RE: Durango, Unit 2

RE: Request for a Minor Amendment to a Site Plan for Subdivision – DRB

Minor Amendment – Durango Unit 2

RE: Proposed Minor Amendments – Durango Subdivision

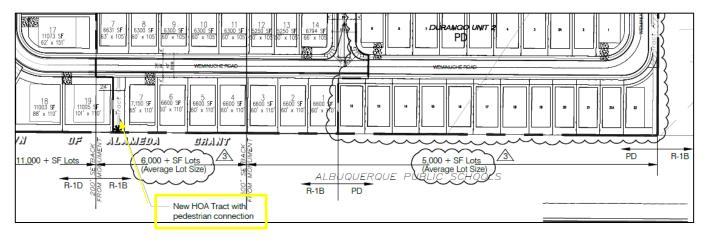
1. Background – p. 2. The 2020 amendment (keyed notes 2) is described as doing three things, one of which was to add an HOA tract that provides pedestrian access on the western side of Unit 1. Can you please help me locate this tract in the current submittal?

<u>Response</u>: Pedestrian access is provided through "Tract C" located on the southern edge in Unit 2 (see detail below).
